Dewberry Response to USGS Review Middle Counties Acquisition and Classification for FEMA VA LiDAR

Produced for U.S. Geological Survey

USGS Contract: G11PD00089

Report Date: 10/19/2012

Figure 1 - Before/After image of DEM_S13_9658_20 showing that the data gap is addressed in the new delivery.

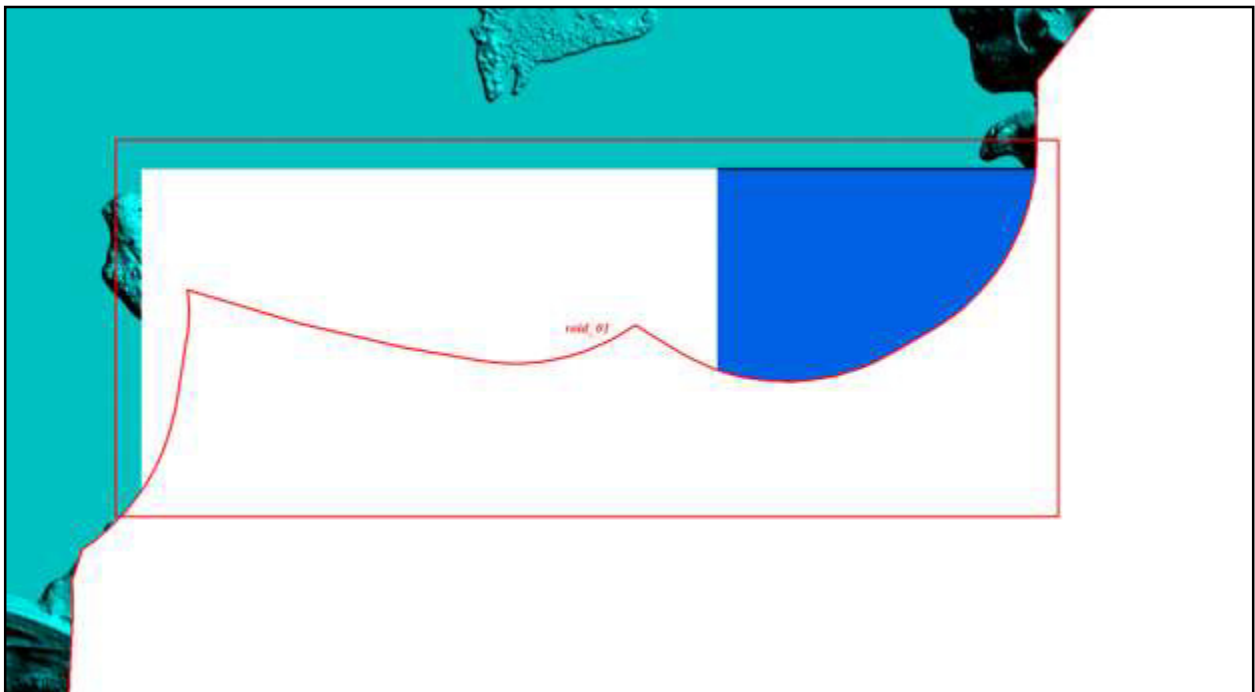
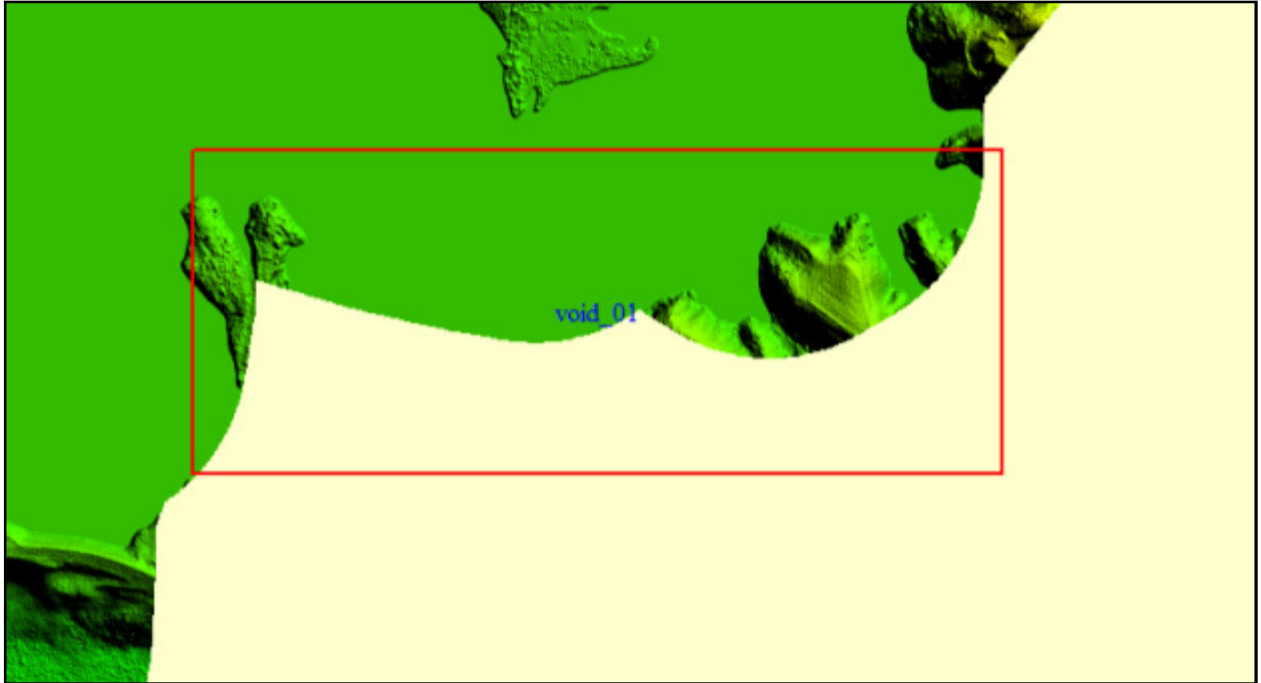
The USGS identified a tile with a void due to a processing error. The DEM was recreated to remove this error from the data.

Figure 2 - Before/After of tile DEM_ S13_9626_40 showing that the lake/pond feature is now hydro-flattened in the DEM. The breakline features have been added to the breakline GDB.

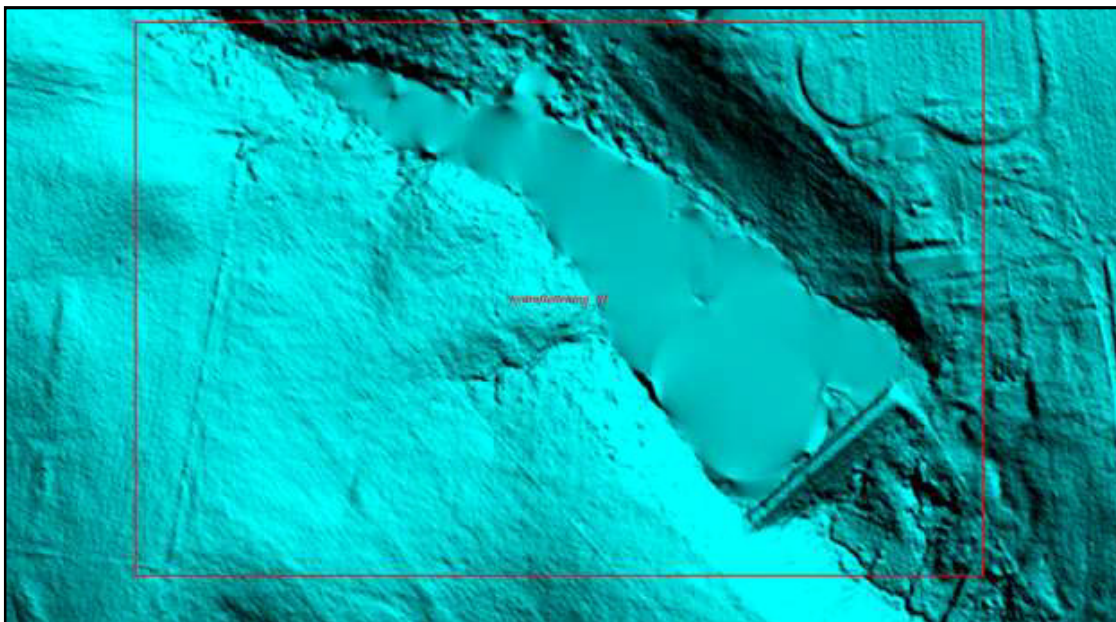
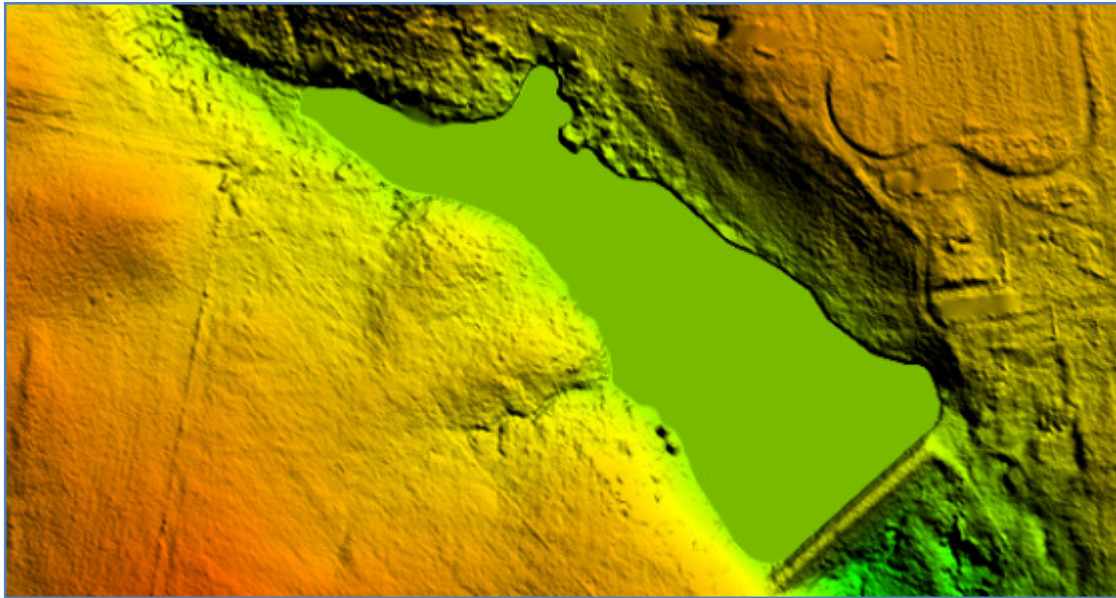
The USGS identified five missing lake/pond features that meet project specifications for collection. The lake/pond features have been added to the breaklines in the 2nd delivery and the LAS and DEMs were reprocessed to address the modifications. An example of the applied corrections can be seen below in Figure 2.

Figure 3 - Before/After of DEM tiles S13_8784_40, S13_8794_10, S13_8783_30, and 8793_20. The void caused by the seam line between the tiles has been removed.

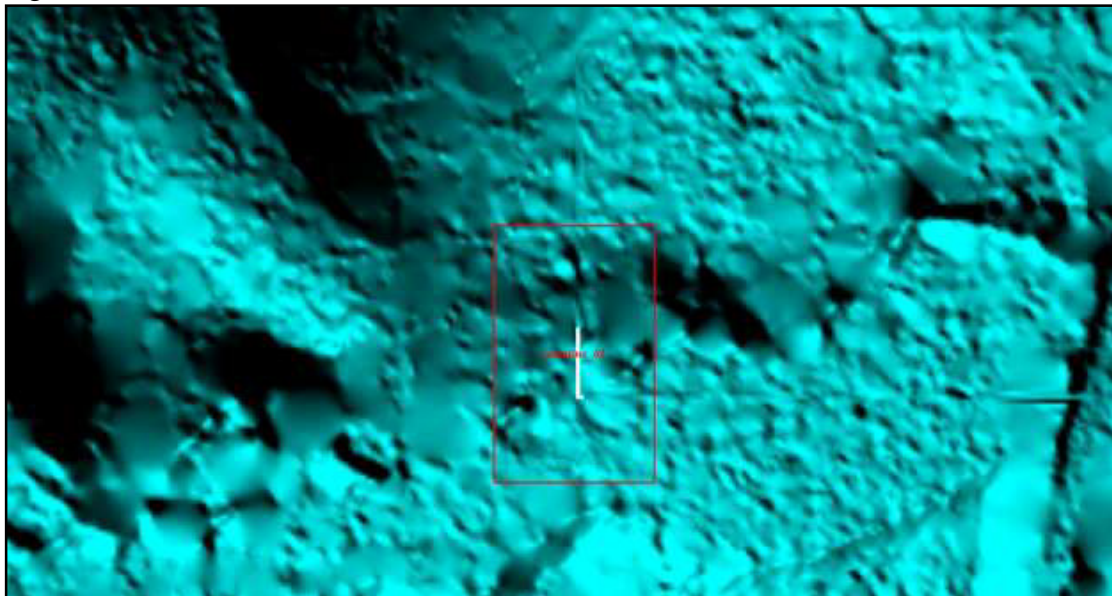
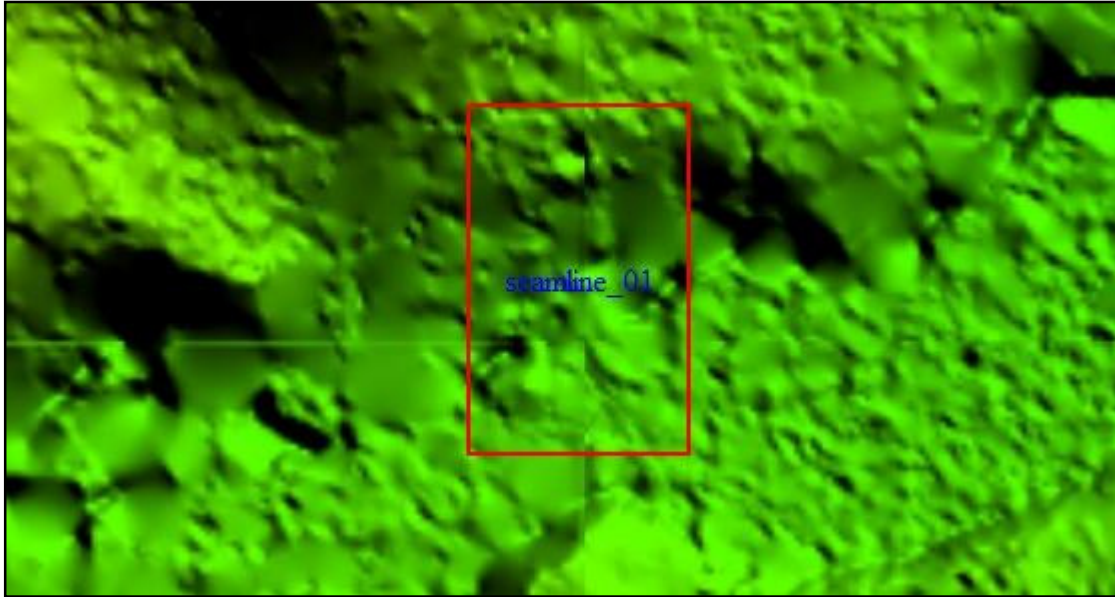
The USGS identified two areas where seam lines between DEM tiles were causing small voids. These two errors occurred at the intersection of 4 DEM tiles each, therefore 8 DEM tiles were reprocessed to remove these errors. An example of the applied corrections can be seen below in Figure 3.

Figure 4 - Image provided by USGS of digital elevation model for tile DEM_S13_8516_30.

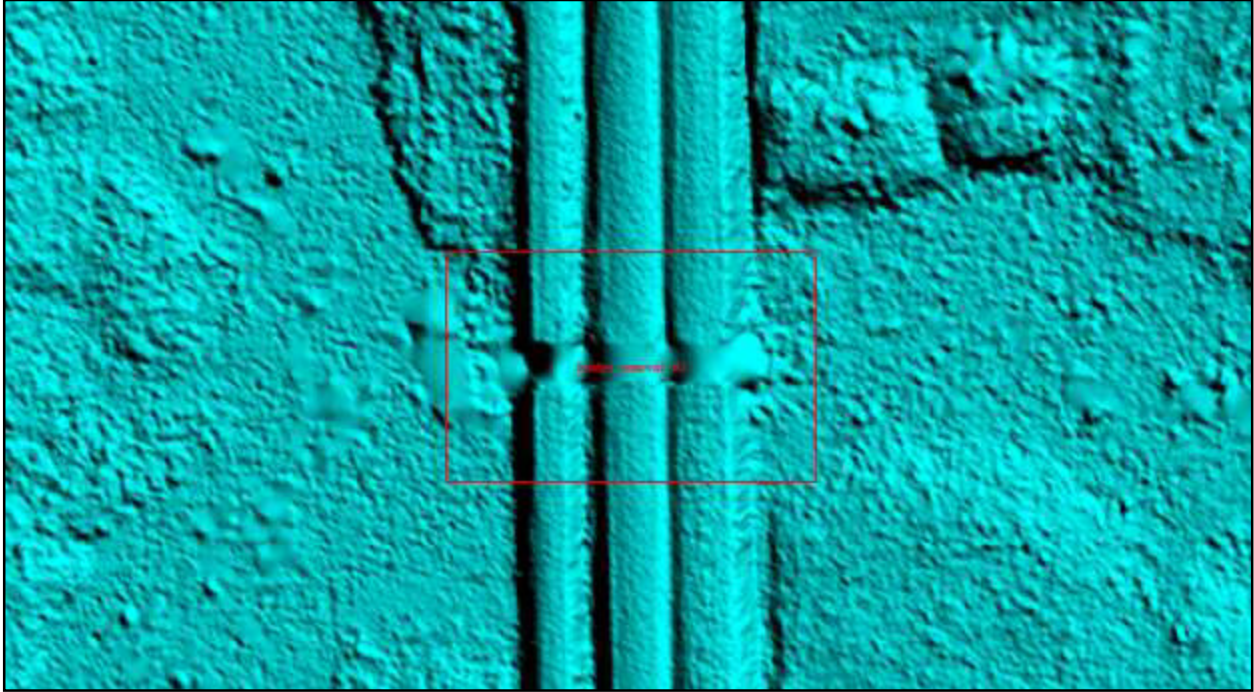
The USGS identified two occurrences where it appeared bridges or portions of bridges were left in the bare-earth surface. Dewberry reviewed these bridges and verified that no bridge points were left in the ground surface. The DEM surface models are created from TINs or Terrains. TIN and Terrain models create continuous surfaces from the inputs. Because a continuous surface is being created, the TIN or Terrain will use interpolation to triangulate across a bridge opening from legitimate ground points on either side of the actual bridge. This can cause visual artifacts or “saddles.” These “artifacts” are only visual and do not exist in the LiDAR points or breaklines. No points were modified at these locations. Figures 4 -6, below, show the bridge features are classified correctly.
